Subject: **WATTS BAR NUCLEAR PLANT (WBN) UNIT 2 - RESPONSE TO
LARGE BREAK LOSS OF COOLANT ACCIDENT (LBLOCA) AND
OVER-PRESSURIZATION REQUEST FOR ADDITIONAL
INFORMATION**

Watts Bar Unit 2 (WBT) Responses to Request for Additional Information (RAI) – BE LOCA Data for Transmittal to NRC

**WATTS BAR NUCLEAR PLANT UNIT 2
WATTS BAR UNIT 2 LOSS OF LOAD RESULTS
WITH NO CREDIT FOR THE FIRST SAFETY GRADE TRIP**

Figure 1. Watts Bar Nuclear 2: WCOBRA/TRAC Reactor Vessel noding diagram.

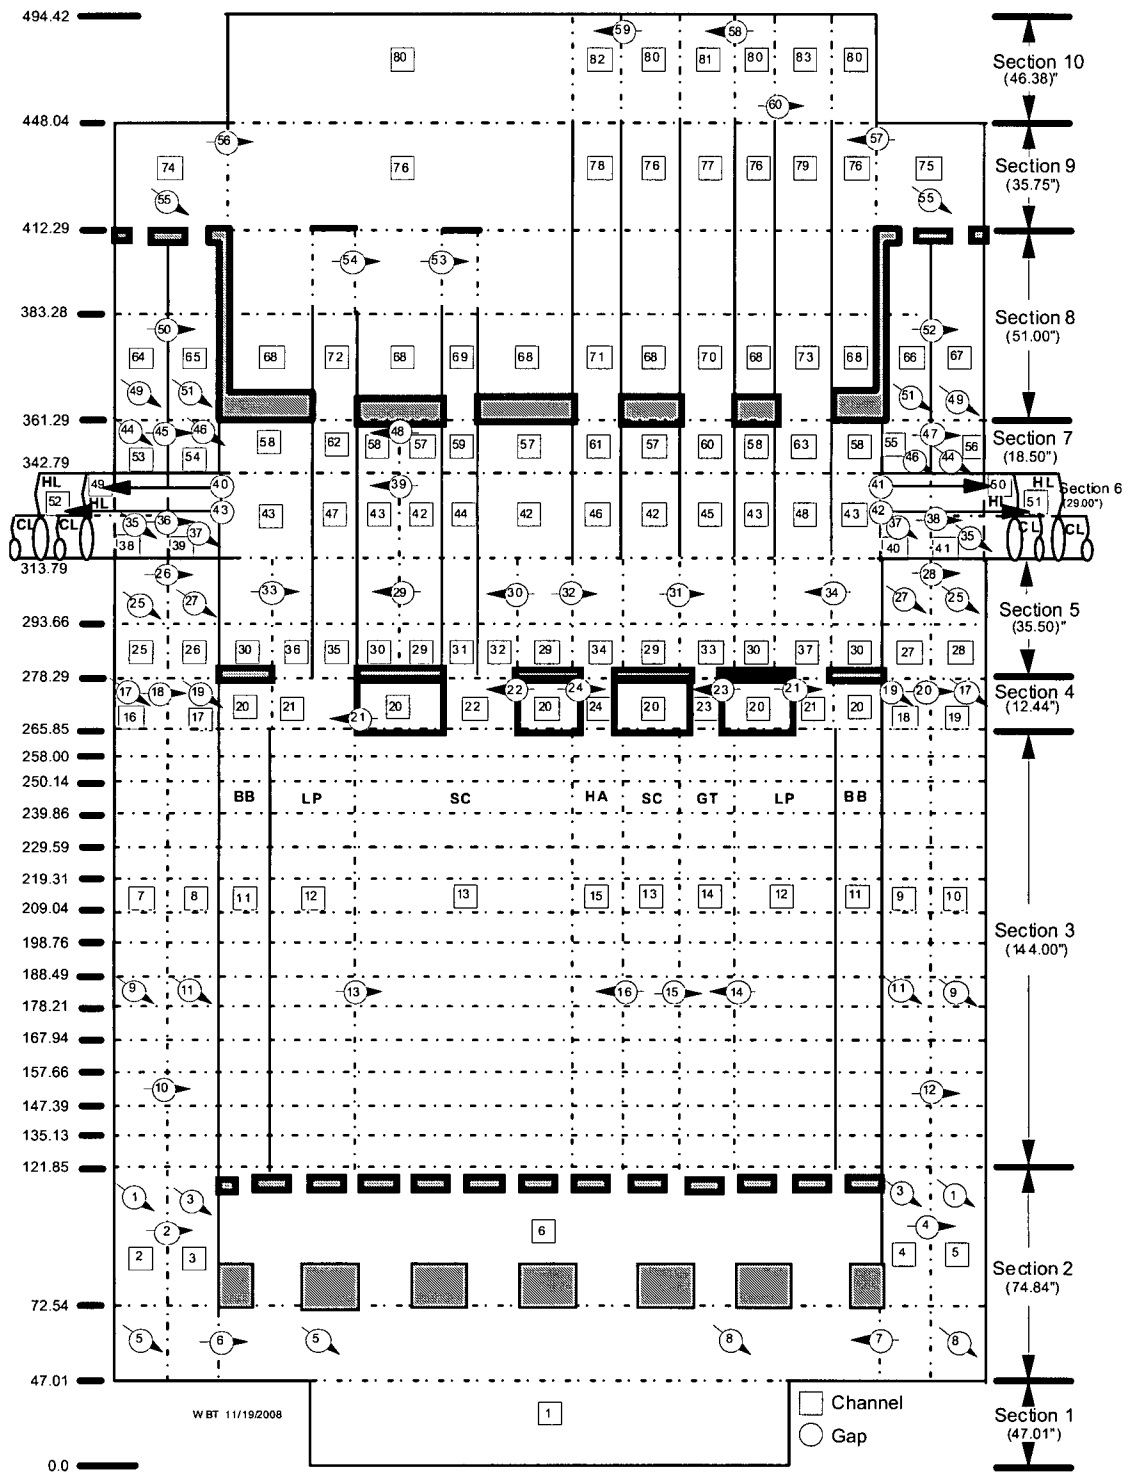
RAI 2: Provide WCOBRA/TRAC noding diagram.

Noding diagram provided in Figures 1 and 2.

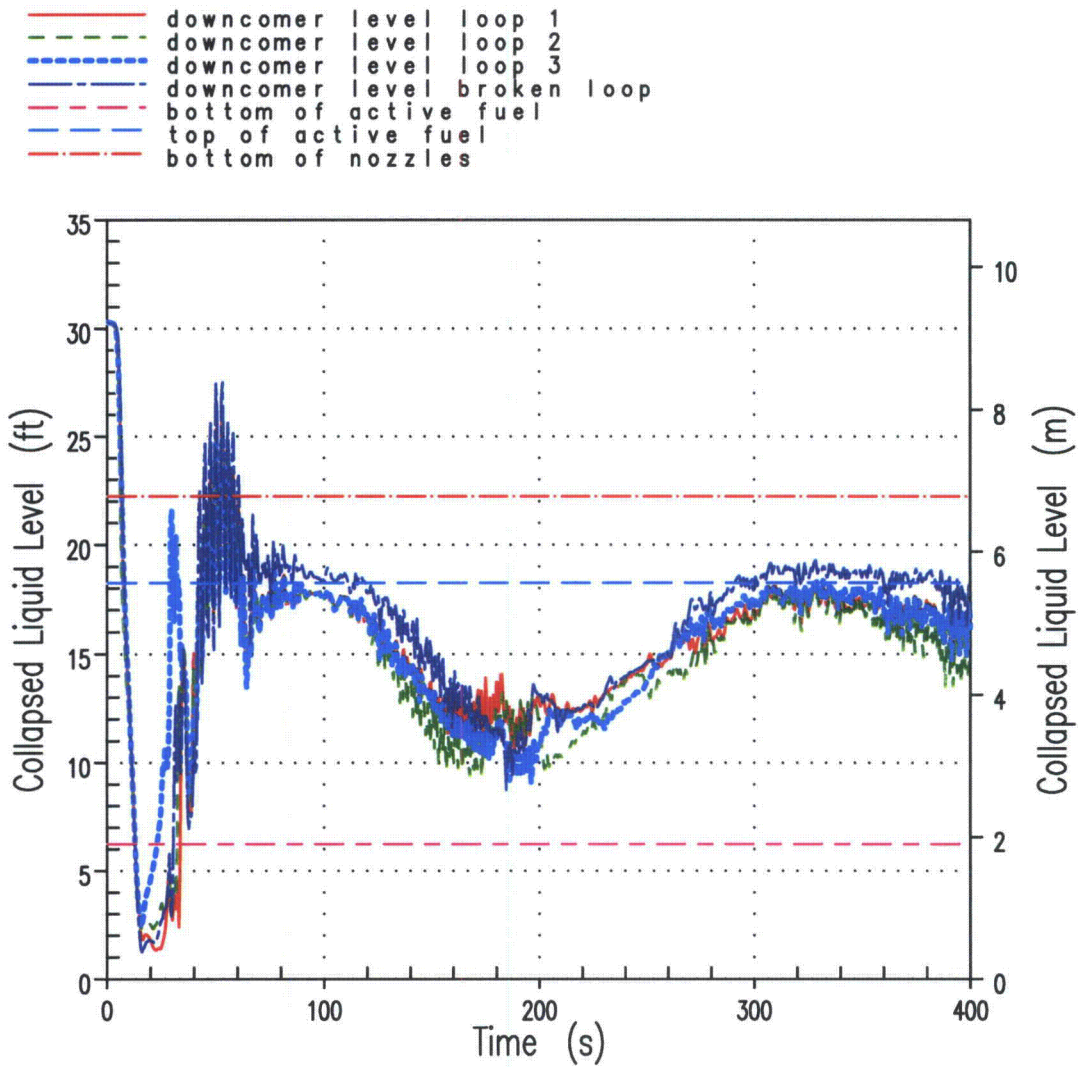
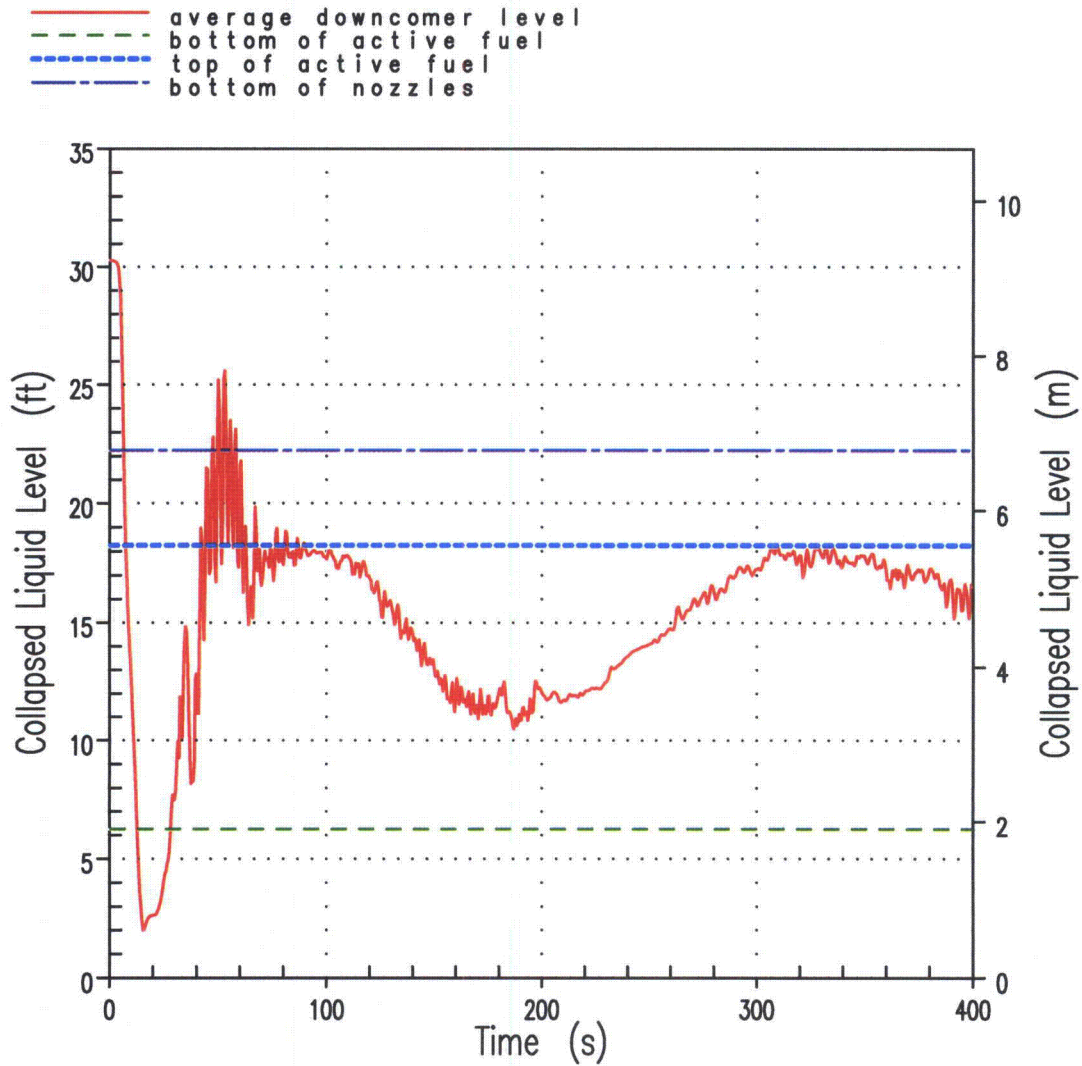
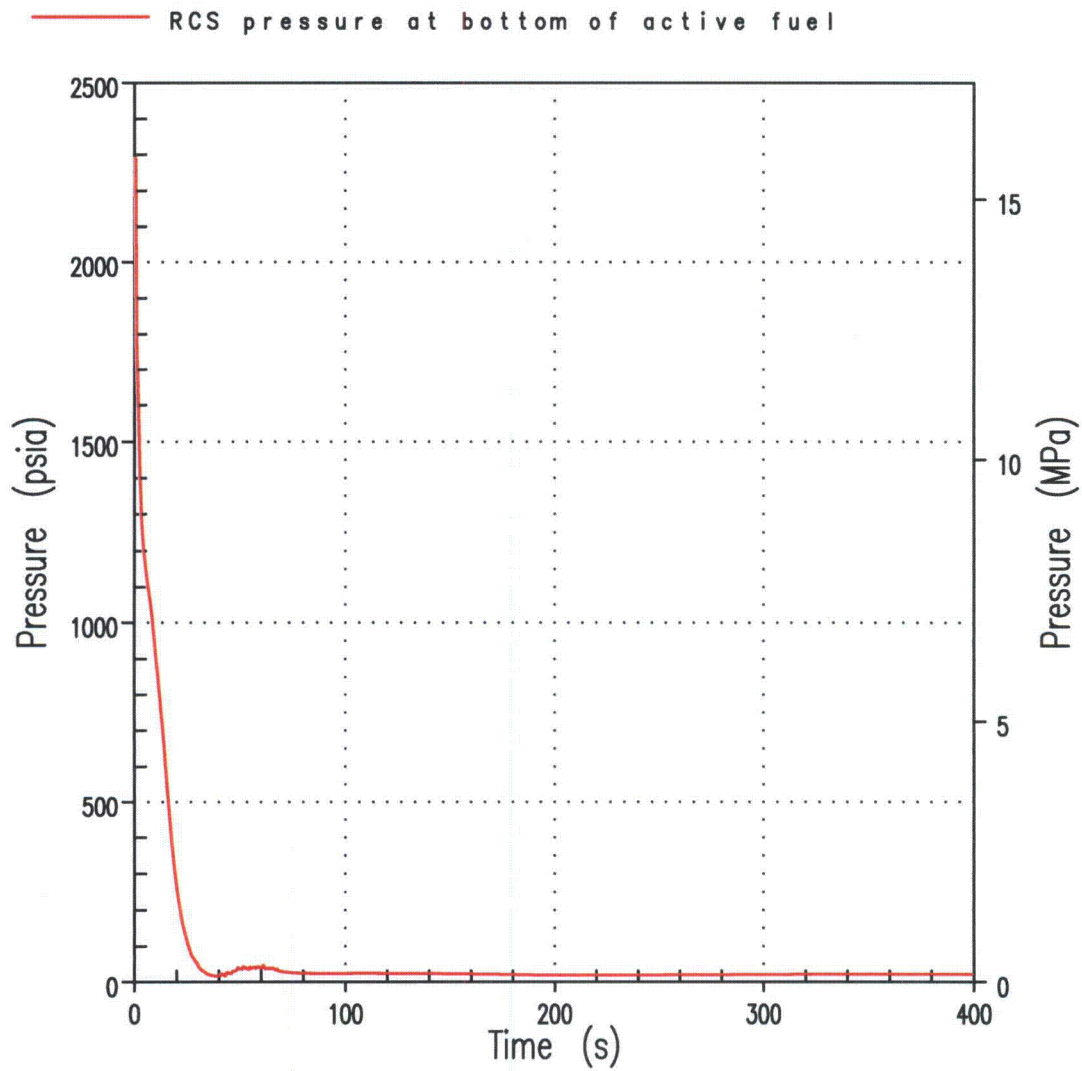
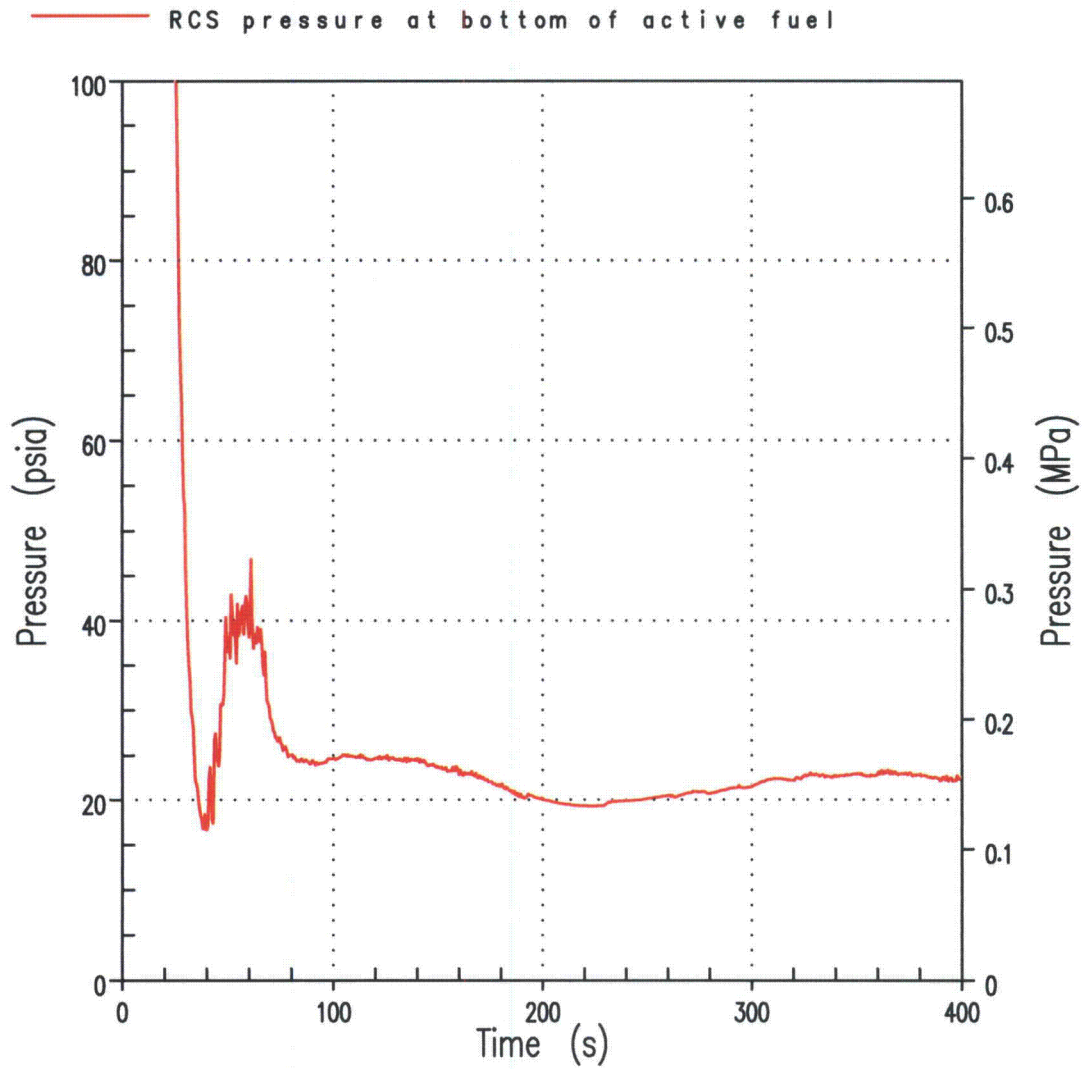
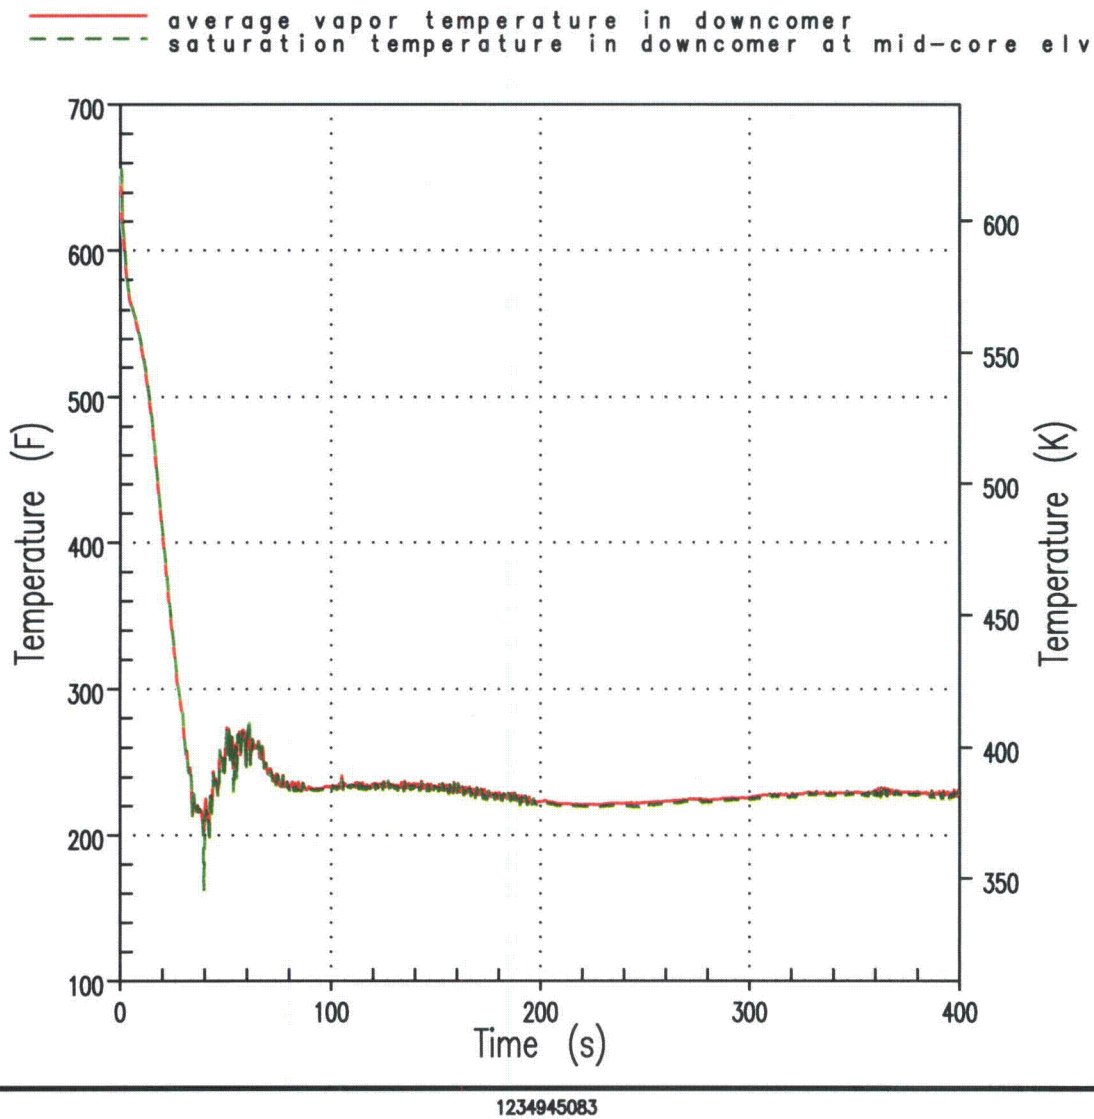
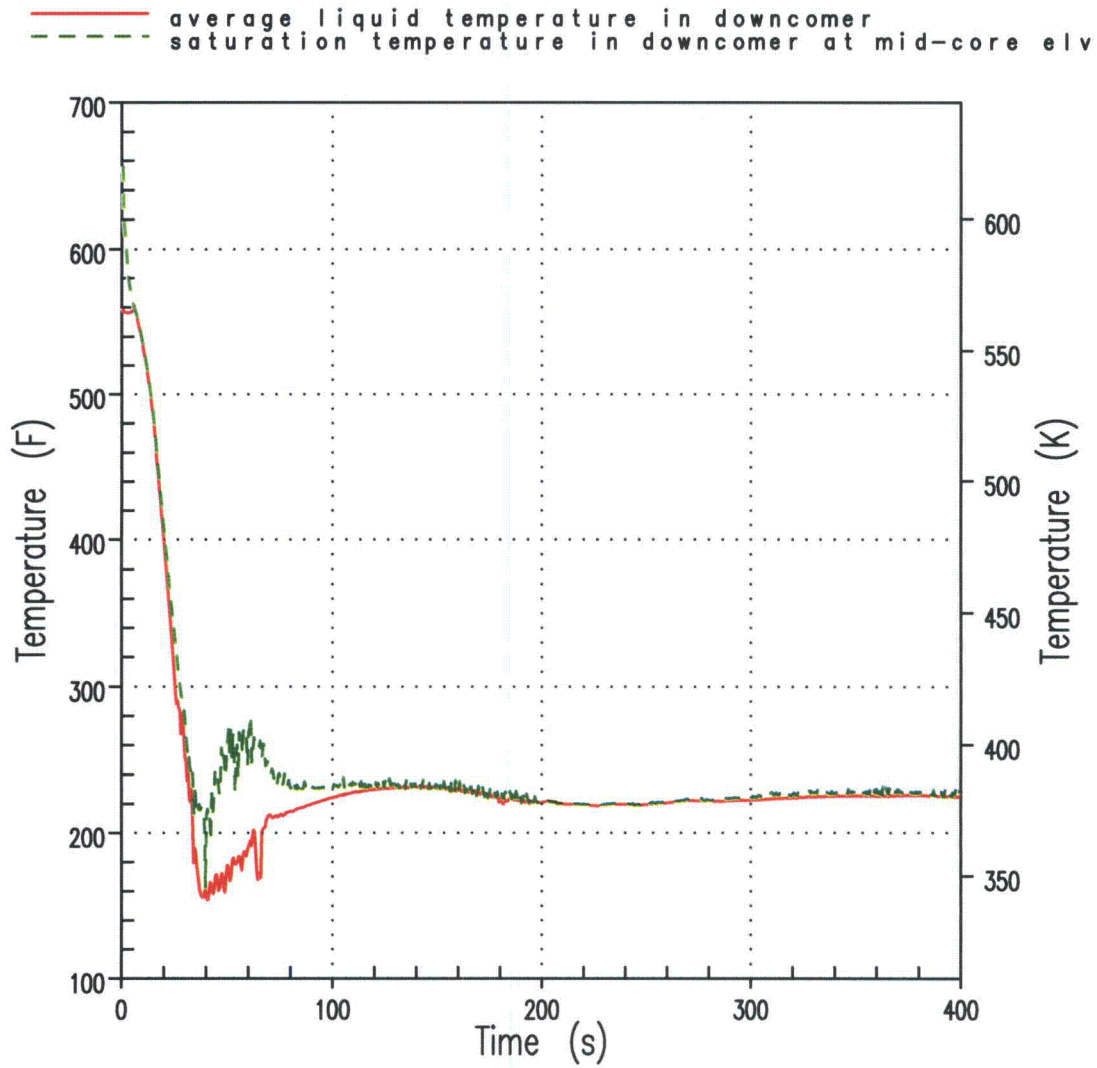
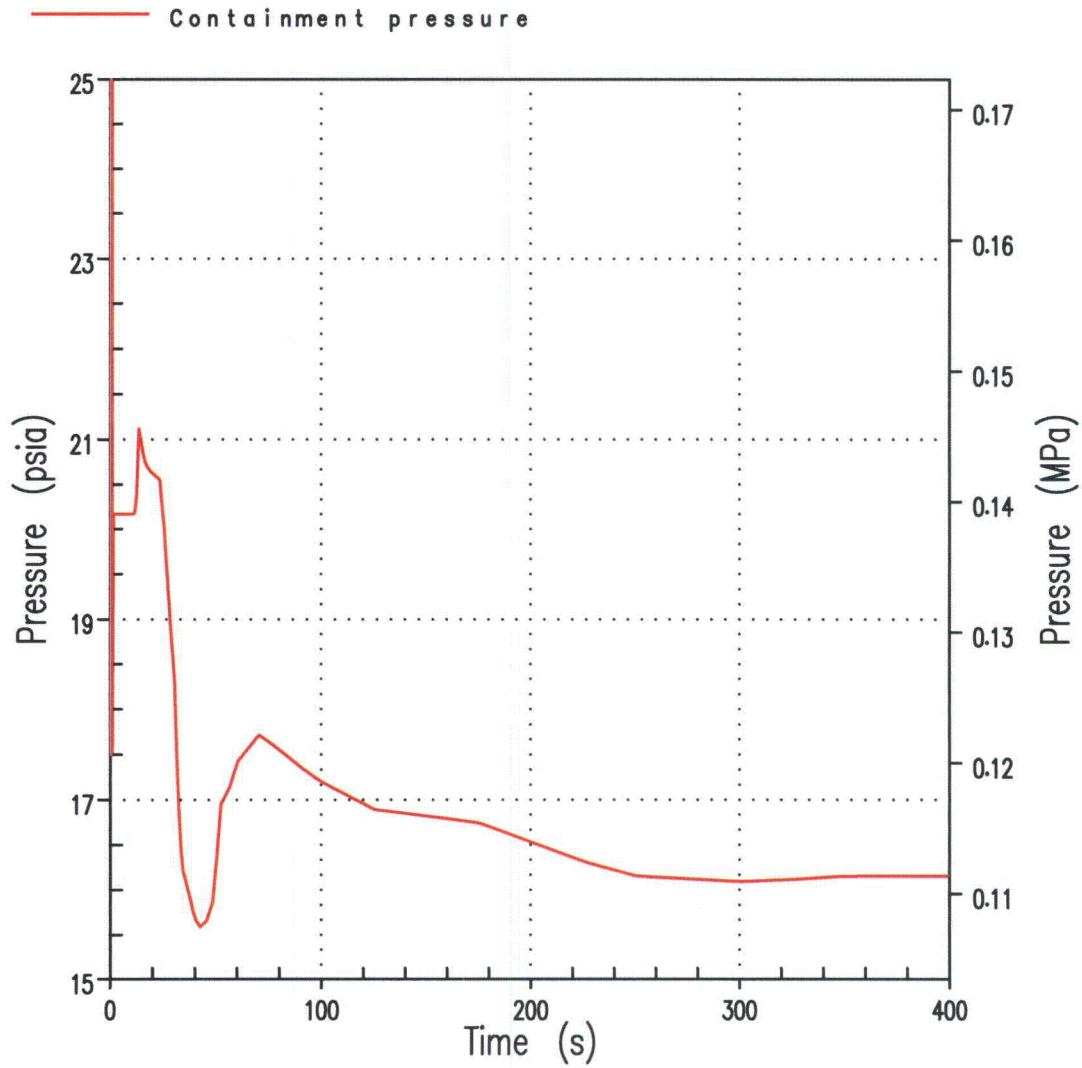
RAI 4: Provide the following data:

Downcomer level
RCS pressure
Fluid temperatures in downcomer
Containment Pressure
ECCS flow
Peak clad temperature (PCT)
Fluid temperatures at the PCT location
Heat transfer coefficients at the PCT location
Core level

Requested data are provided in Figures 3 through 16. Note that PCT plot is from the hot rod (HOTSPOT) calculation. The PCT location is at elevation 2926 mm (115.2 in) above bottom of fuel. Other plots are from the WCOBRA/TRAC calculation.
